Access Compliance Report

Public Rights-of-Way (Curb Ramps)

Intersection ID: 49248	Main Street: BOOMERANG_WY	Cross Street: PROSPERITY_VIEW_DR	Location: NE
ADA ID: 6F2848D8C374	Ramp Type: BlendTrans1	Initial Pass/Fail: Fail	Overall Compliance: No
		Severity Score: 10

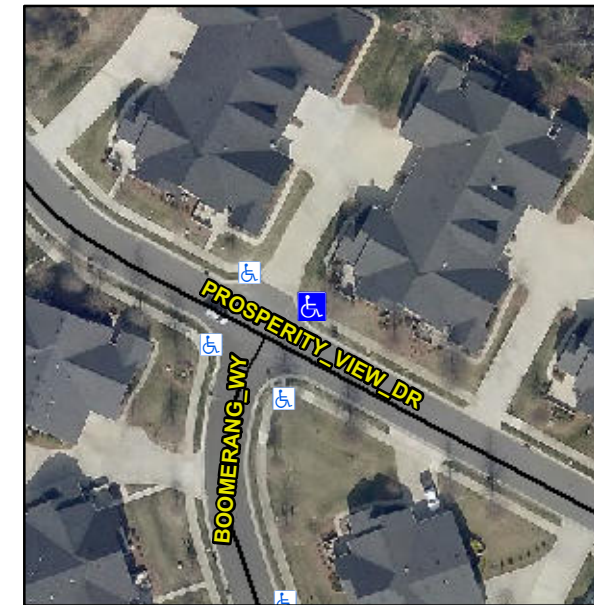
Not Found, R304.5.1

Compliance	Description	Data	Compliance	Description	Data
N/A	Ramp Length (in)	46.0	Yes	BlendTrans Slope (%)	4.5
No	Ramp Width (in)	47.0	Yes	BlendTrans XSlope (%)	2.9
N/A	Flare Type LT	N/A	N/A	Flare Type RT	N/A
N/A	Flare Slope LT (%)	N/A	N/A	Flare Slope RT (%)	N/A
N/A	Flare Traversable LT?	N/A	N/A	Flare Traversable RT?	N/A
N/A	Landing Length (in)	N/A	N/A	DWS Provided?	N/A
N/A	Landing Width (in)	N/A	N/A	DWS Contrast?	N/A
N/A	Landing Slope (%)	N/A	N/A	DWS Length (in)	N/A
N/A	Landing X Slope (%)	N/A	N/A	DWS Full Width?	N/A
N/A	Landing Curb? (Y/N)	N/A	N/A	DWS Offset (in)	N/A
N/A	Shared Landing?	N/A			
N/A	Gutter Ponding?	N/A	N/A	Gutter Slope (%)	N/A
N/A	Gutter Lip Ht (in)	N/A	N/A	Gutter X Slope (%)	N/A
N/A	Painted X Walk1?	No	N/A	Painted X Walk2?	No
	X Walk 1 Direction	To NW		X Walk 2 Direction	To S
	X Walk 1 Width (in)	N/A		X Walk 2 Width (in)	N/A
	X Walk 1 Slope (%)	1.0		X Walk 2 Slope (%)	2.2
	X Walk 1 X Slope (%)	4.8		X Walk 2 X Slope (%)	1.5

N/A	Ramp inside XWalk1?	N/A	N/A	Ramp inside XWalk2?	N/A
	Road Slope (%)	5.1		Clear Space?	N/A
	Road X Slope (%)	3.2	N/A	Clear Space to XWalk (in)	N/A
N/A	Any Obstructions?	N/A	N/A	Storm Grate/Utility Hazard?	N/A
	Obstruction Type			Storm Grate/Utility Type	
		N/A			N/A
			Yes	Surface Condition? (G/P)	Good
			No	Curb Slope (%)	15.0

Remove & Replace Curb Ramp With Two New Directional Ramps or Equivalent.
